COLORADO DIVISION OF RECLAMATION, MINING AND SAFETY
MINERALS PROGRAM INSPECTION REPORT
PHONE: (303) 866-3567

MINE NAME: Cresson Project	MINE/PROSPECTING ID#: M-1980-244	MINERAL: Gold	COUNTY: Teller
INSPECTION TYPE: Aerial Inspection	INSPECTOR(S): Timothy A. Cazier	INSP. DATE: August 28, 2015	INSP. TIME: 09:05
OPERATOR: Cripple Creek & Victor Gold Mining Company	OPERATOR REPRESENTATIVE: None	TYPE OF OPERATION: 112d-3 - Designated Mining Operation	
REASON FOR INSPECTION: Normal I&E Program	BOND CALCULATION TYPE: None	BOND AMOUNT: \$136,475,000.00	
DATE OF COMPLAINT: NA	POST INSP. CONTACTS: None	JOINT INSP. AGENCY: None	
WEATHER: Clear	INSPECTOR'S SIGNATURE: 	SIGNATURE DATE: September 1, 2015

Photo 9. Squaw Gulch VLF (Looking NE) [Note significant ponding in PSSA].

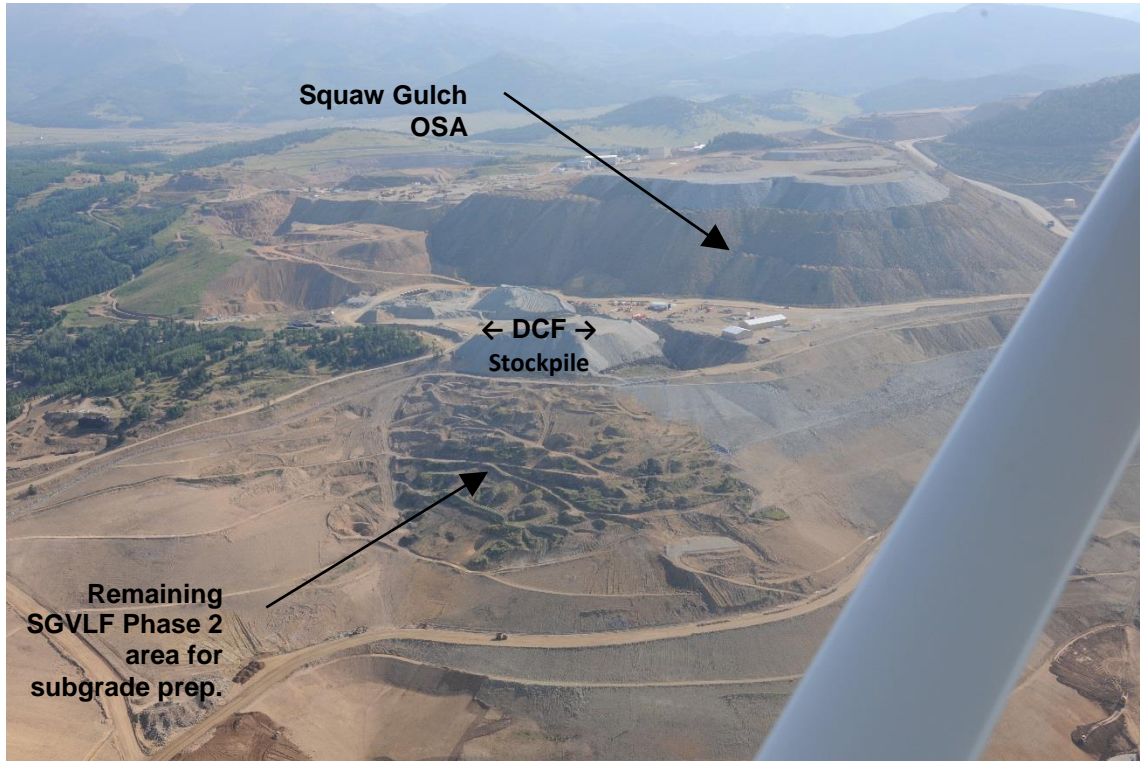
PROBLEM/POSSIBLE VIOLATION: Problem: A significant amount of potentially impacted water was observed in the SGVLF PSSA. This is a potential wildlife attractant.

PROBLEM/POSSIBLE VIOLATION: Problem: The observed ponded water in the SGVLF PSSA may pose geotechnical slope instability problems that may lead to sloughing on the certified and approved PSSA liner.

Ponded water was also observed in the PSSA area of the SGVLF (see **Photo 9**). The Division had not expected this amount of potentially impacted water (*potentially impacted as the Division understands impacted water from the new mill area is routed to the PSSA*) being exposed during the construction of the SGVLF. Further, we

could not find any discussion in the approved permit about this condition, but it appears to be a potential wildlife attractant. This ponded condition may also have geotechnical implications on the stability of the DCF covered liner in the PSSA. The saturated toe of the covered liner may lead to slope instability, causing the DCF to slide and potentially damage the certified, approved geomembrane liner in the PSSA. These issues are also cited as problems on p. 1 of this report.

CORRECTIVE ACTIONS: Provide an estimate as to how long this condition may persist and a proposed means to address/mitigate the problem by the Corrective Action due date.

CORRECTIVE ACTIONS: Provide a geotechnical slope stability analysis assuming saturated material exits at the toe of the DCF covered liner to assess the impact on the factors of safety presented in the MLE2/Amendment 10 slope stability exhibit.
